Texas Department of Health

This letter is in response to your request for clarification of information sent to you regarding the request for concurrence of termination of the Westinghouse Uranium Projects, Radioactive Material Licence (RML) L02537. In the information sent there was an indication that the Texas Natural Resource Conservation Commission (TNRCC) had an action pending relating to the termination of the project. The pending action was the termination of the of the RML by the TNRCC. Since that report was written the authority to license uranium mining projects (and to terminate) was transferred to the Texas Department of Health (TDH). When the program was transferred to TDH the pending action was also transferred and has been sent to you for concurrence. I hope this clarifies this matter for you.

SECTION III

Attachment C

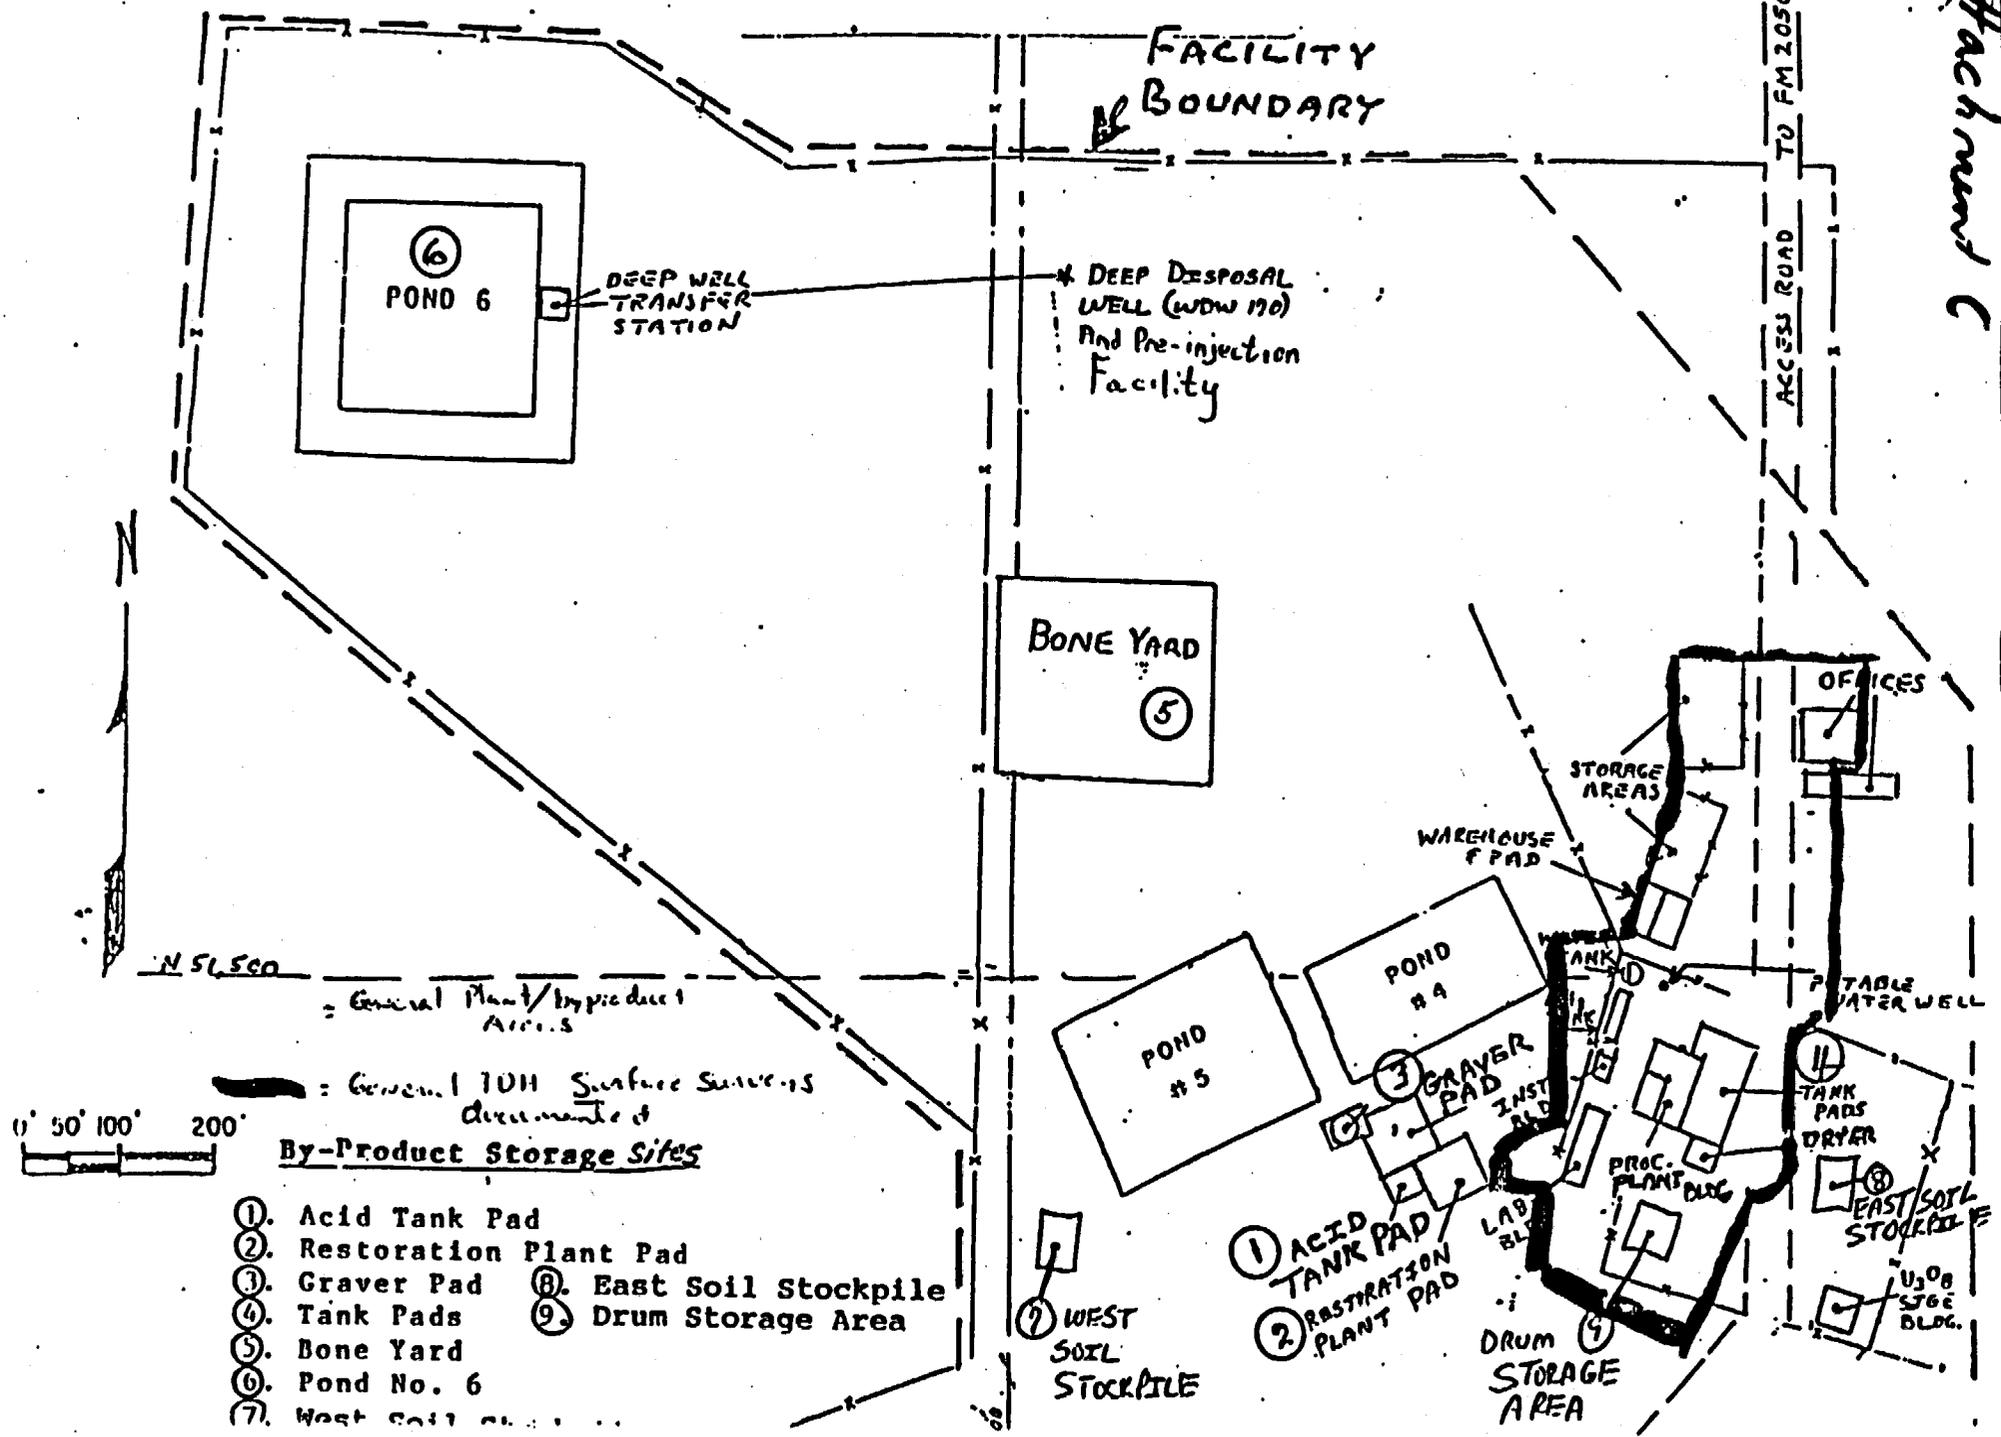
TDH performed a confirmatory grid survey of the plant area; however, only areas (approximately, the area circled in red in attachment C) were included in the confirmatory close out survey. The TDH summary of plant area confirmatory surveys state that the surface areas appear to be within release limits.

11. document confirmatory close out grid/area surveys of all plant and byproduct storage areas in attachment C (yellow area outside of the red circled area), soil sampling may be warranted if areas are twice background or twice surrounding meter readings;
